CITY OF BERKLEY, MICHIGAN SPECIAL MEETING OF THE CITY PLANNING COMMISSION

Subject: **PSP-16-22: 3120 W. Eleven Mile– Moses Roses**
Site Plan Approval

Site Plan Review For City of Berkley, Michigan

Re: Moses Roses
3120 W Eleven Mile Rd
Engineering Site Plan – Review No. 2
City of Berkley, MI

SITE PHOTOMETRIC
SCALE: 1" = 20'-0"

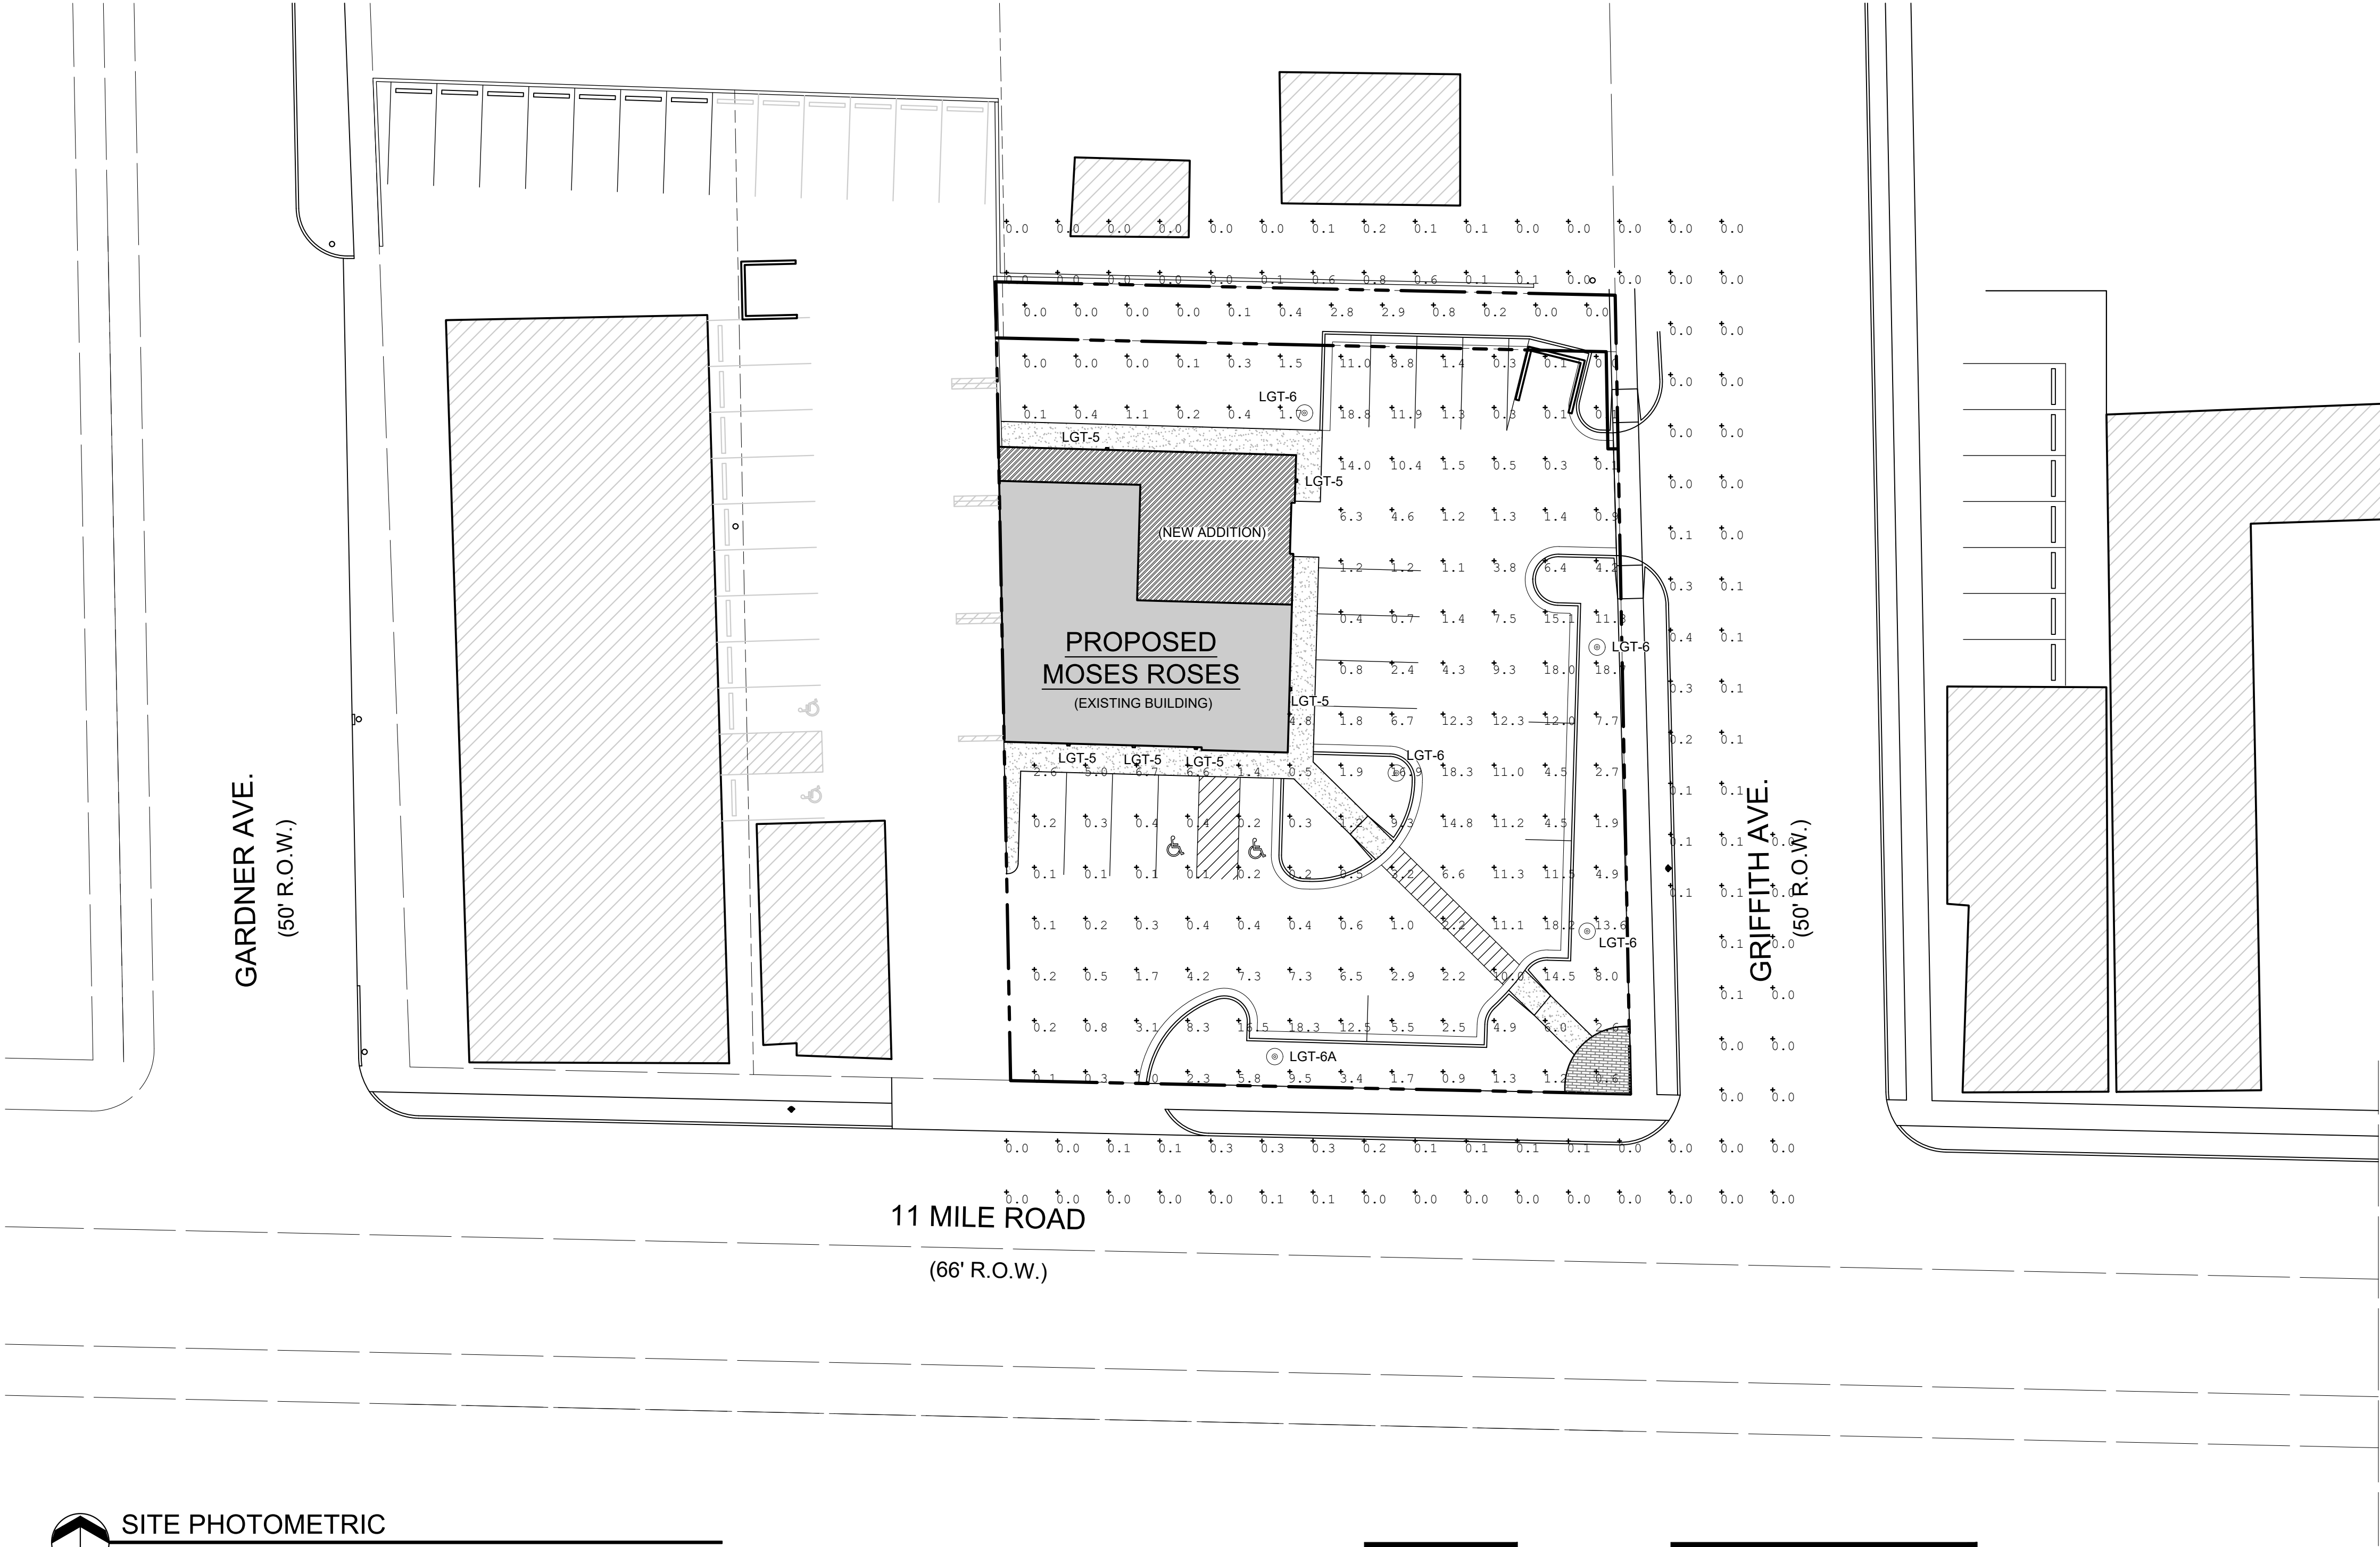
A photometric plan was provided. The applicant is proposing a total of four (4) parking lot pole lights, and five (5) building lights. We note that the pole lights project a maximum footcandles of eighteen (18) footcandles.

1. Provide shared parking agreements to be reviewed by City Attorney.
2. Provide livewall details at pre-construction meeting.
3. Provide green roof plant material at pre-construction meeting.
4. Reduce pole footcandles.
5. Confirm on elevations that the parapet wall is high enough to screen exterior appliances (air conditioners, generators, etc.) to ensure compliance with Section 138-73.

DEMOLITION PLAN

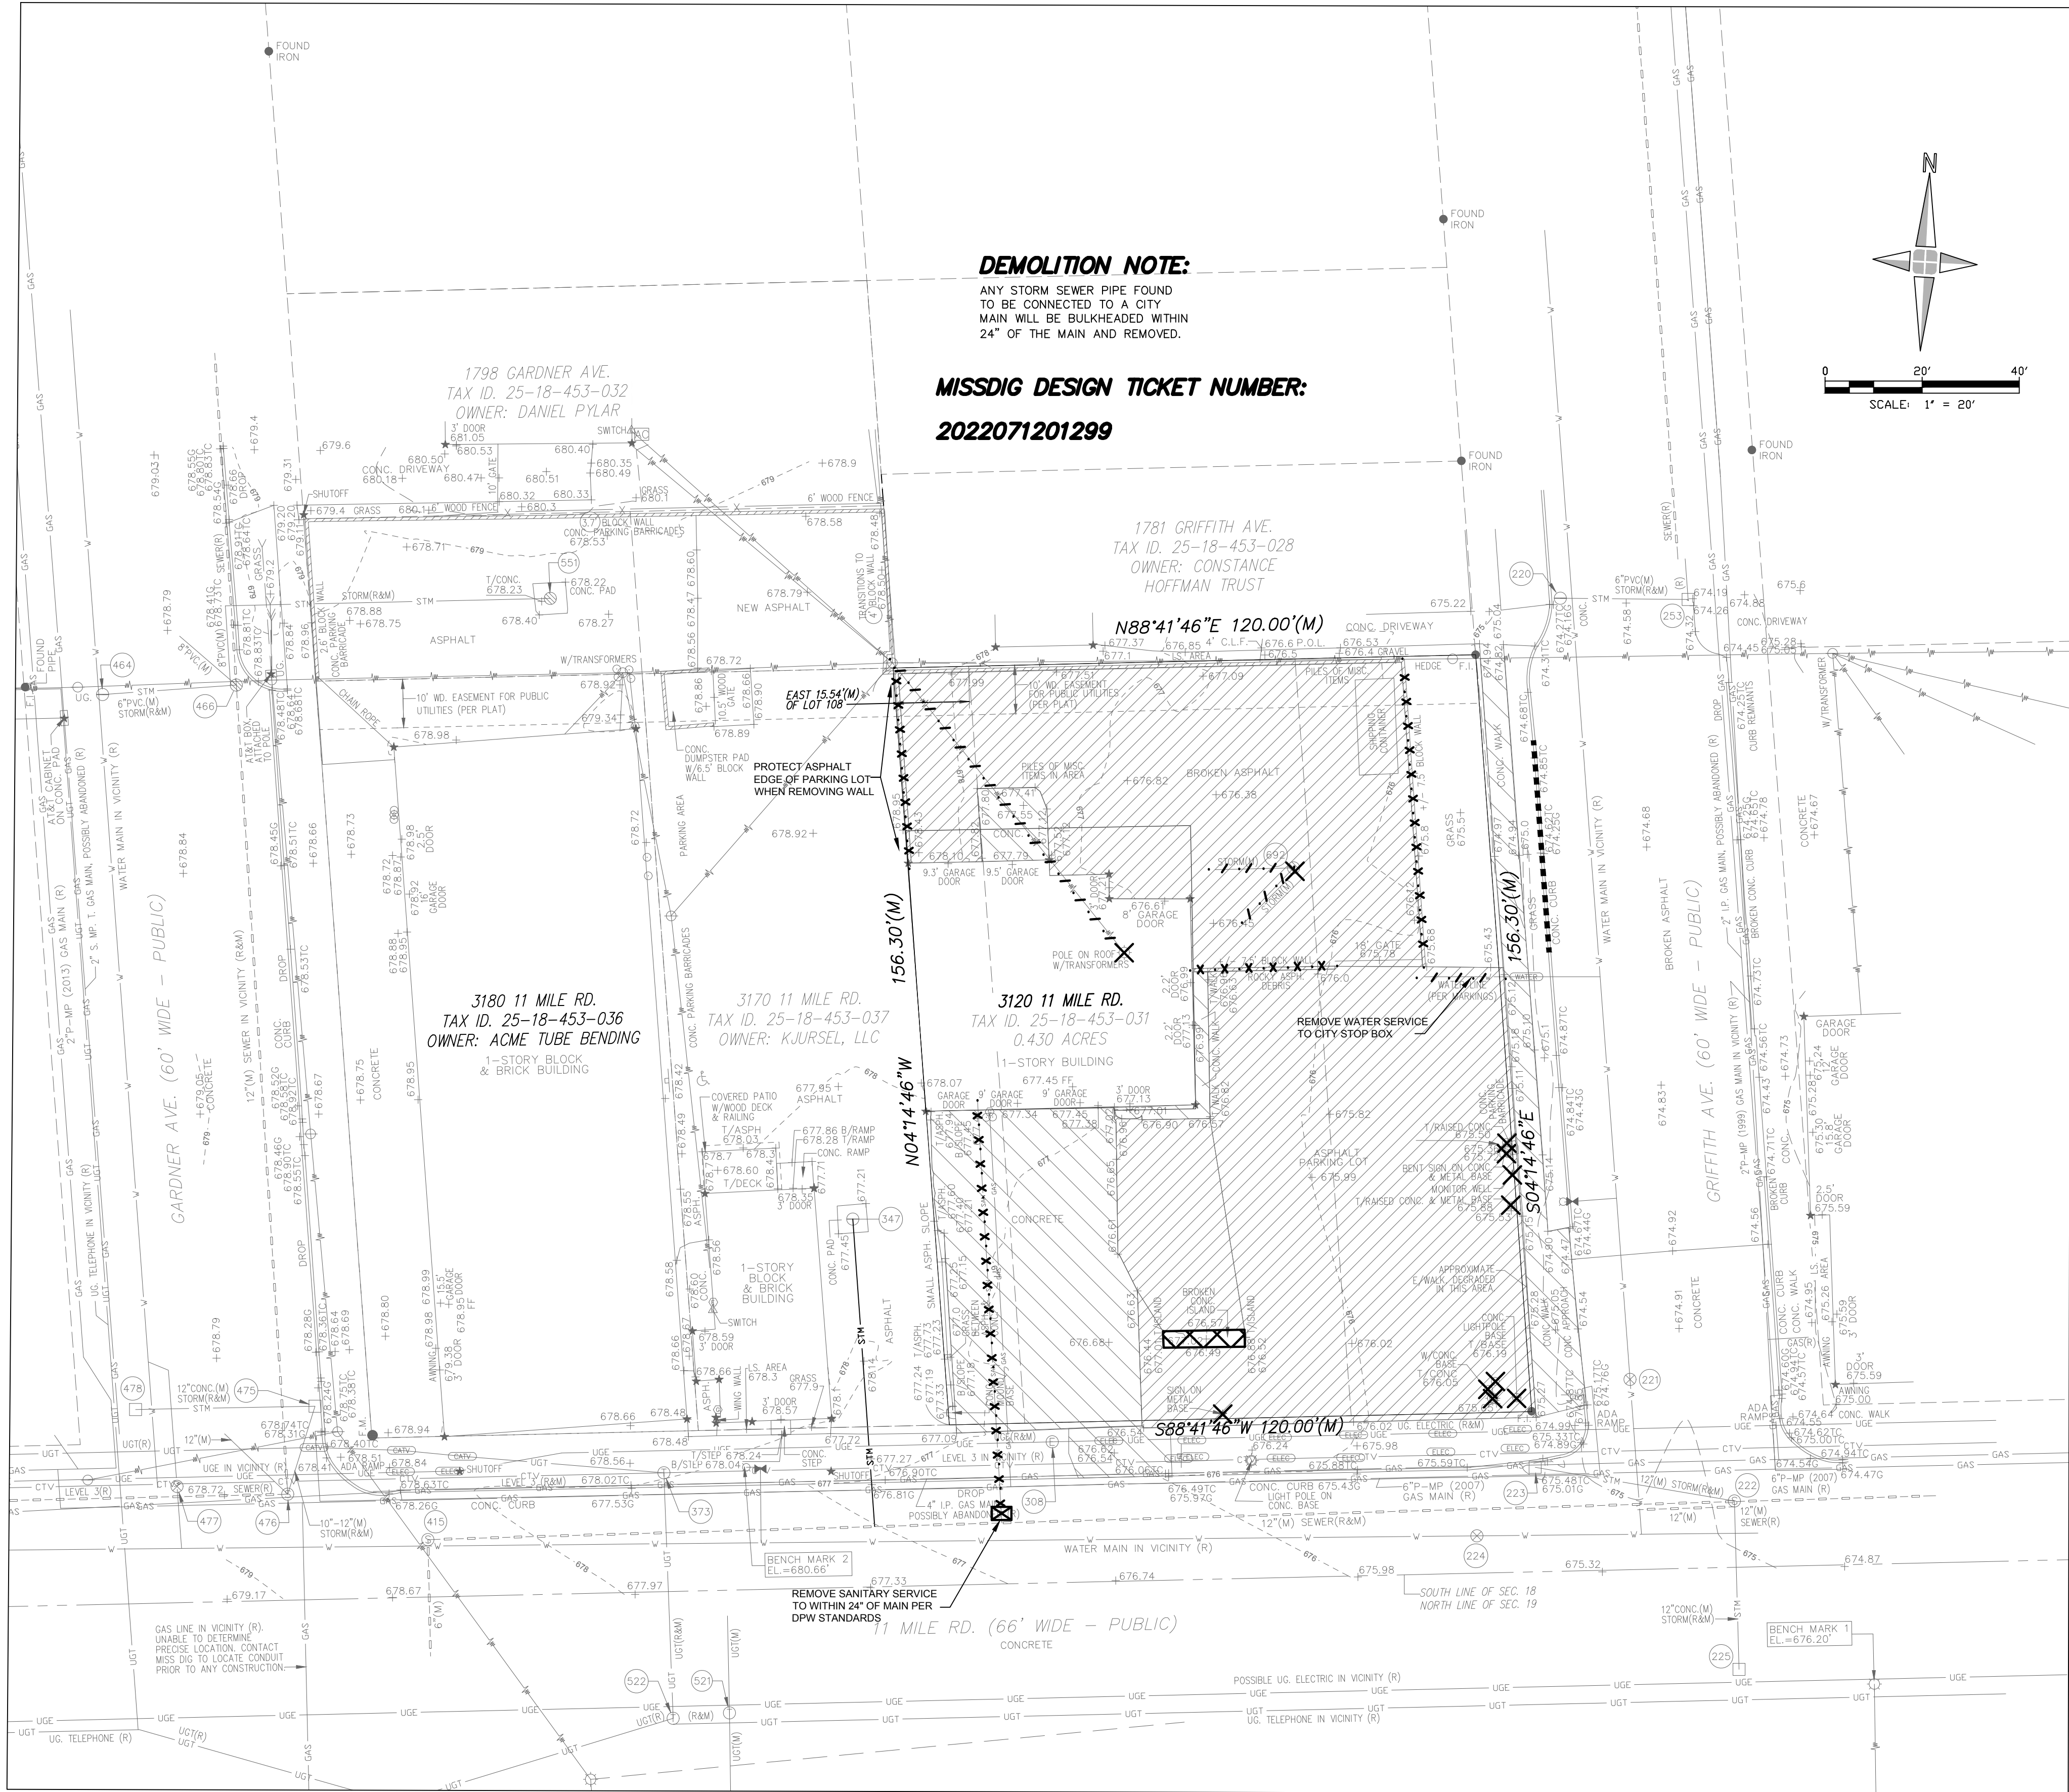
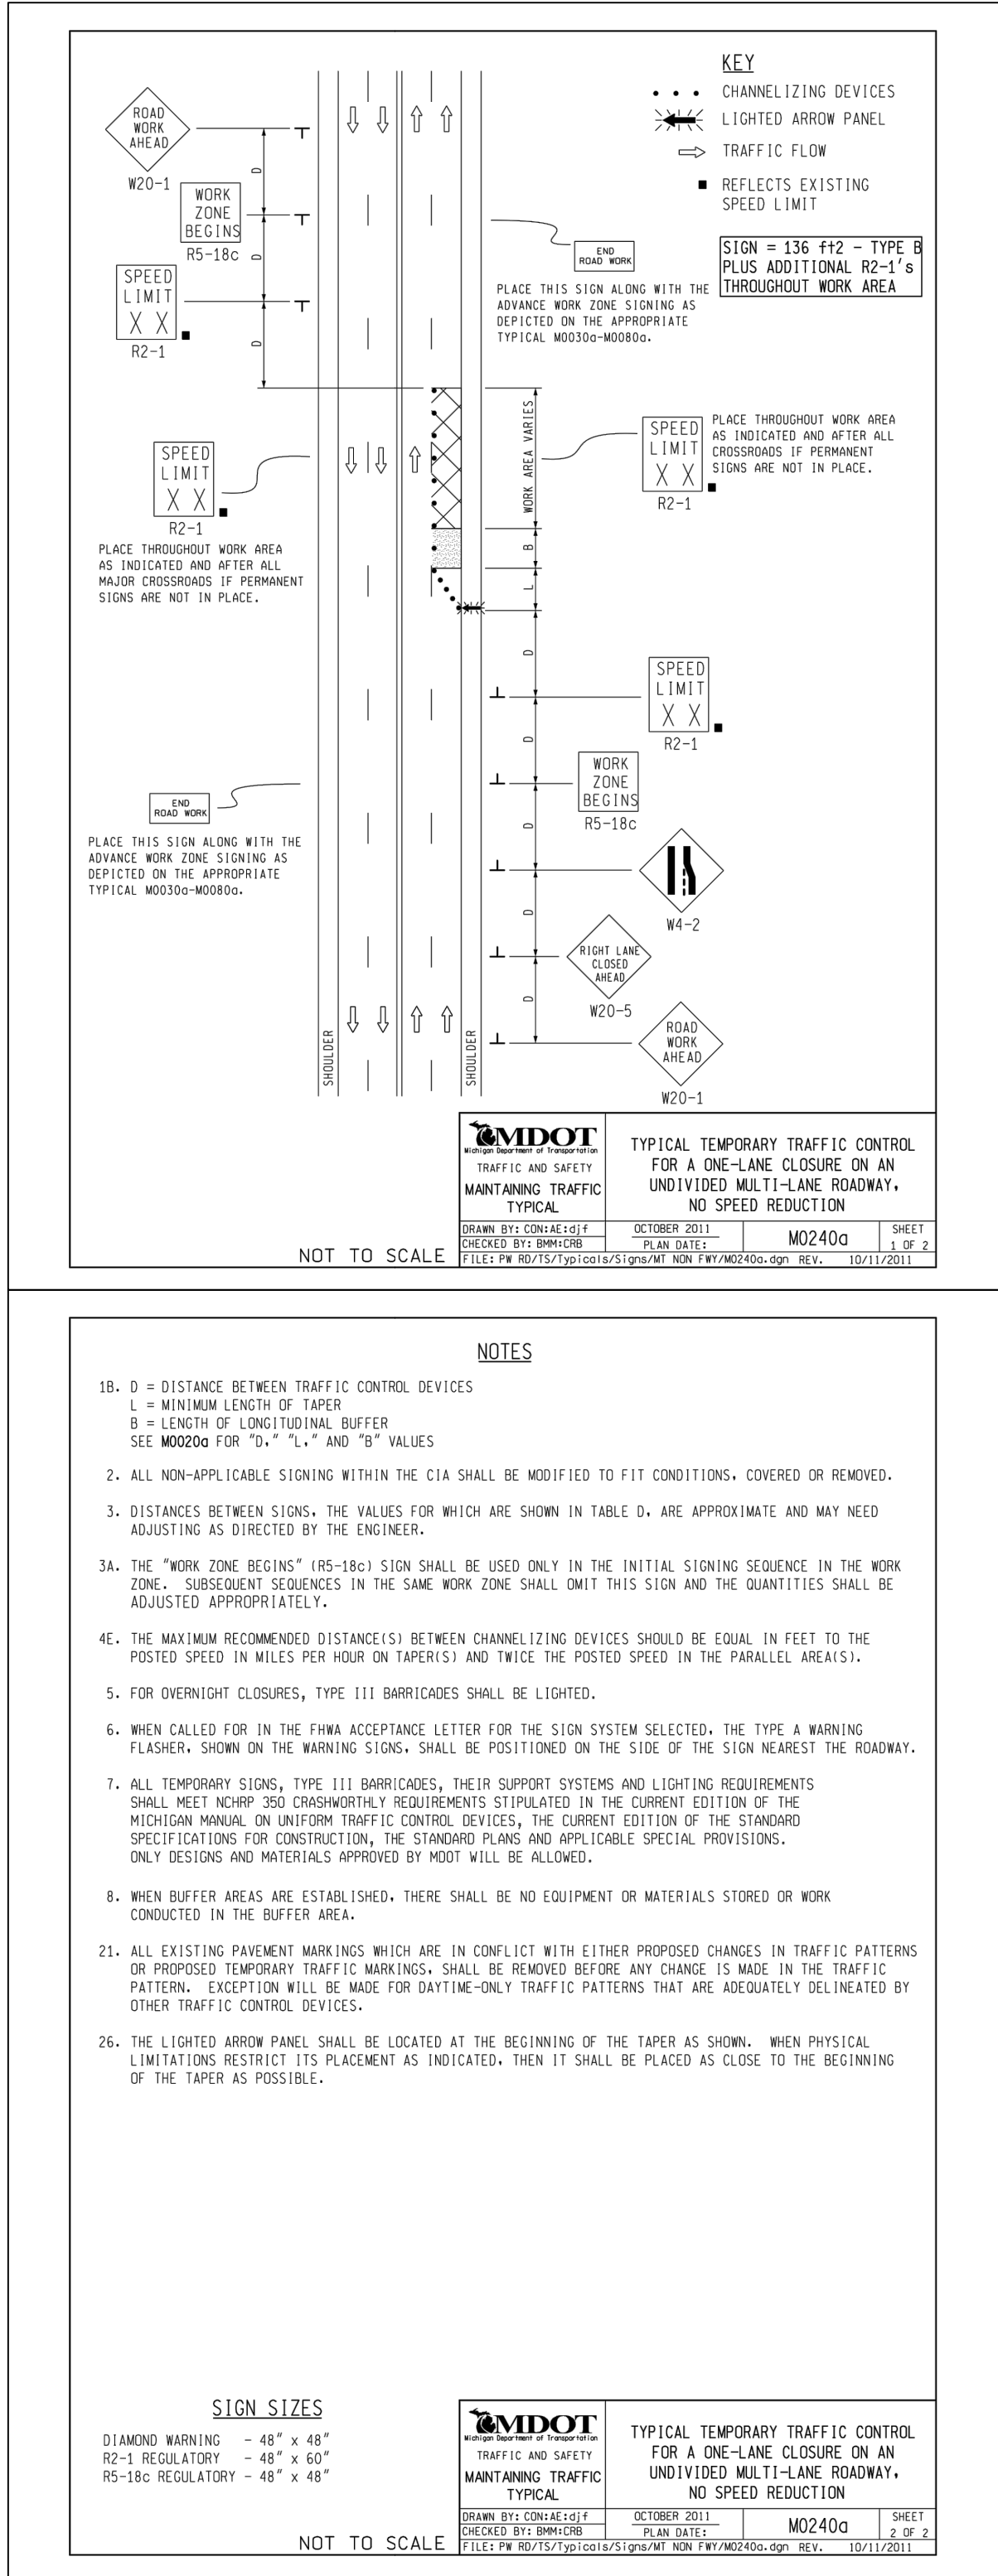
4. The demolition plan calls for the removal of the existing storm structure and a portion of the piping. The applicant will need to verify that this is the full extent of the piping to be removed. If storm was connected directly to the city mainline it will need to be retired within 24" of the main sewer. This work could potentially impact the 11 mile right of way and the location should be indicated on the plan.

5. A traffic control plan has been added to the plan set to account for the proposed work in the 11 Mile roadway but it does not appear to cover the scope of work that will need to be completed. The plan is for a single lane closure and it appears that a multiple lane closure with a traffic shift would be needed to safely accommodate the utility work. A multilane closure would push traffic onto the eastbound side of 11 mile that is owned and maintained by the City of Oak Park. An updated traffic control plan should be submitted to both the City of Berkley and the City of Oak Park with the City of Oak Park's response shared before final approval.
6. A Storm Water Service Fixed Charge will be assessed upon completion of construction. This charge will be reflected on the regular utility bill.
